KIA MOTORS

NUMBER
028 (Revised)

TECHNICAL SERVICE BULLETIN

3.8/3.3L ENGINE NOISES

Noise 3 – Catalyst Heat Shield Buzzing / Rattling Under Slight Load

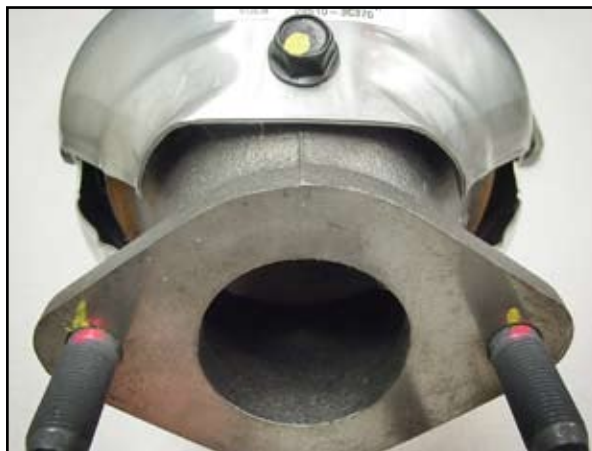
Noise can occur with less than 3mm clearance between catalyst and heat shield.

Good clearance of more than 3mm.

Check and if necessary adjust ALL heat shields on both front and rear catalysts. A good inspection measurement can be taken with a 3mm hex wrench.

Example of correct heat shield clearance.
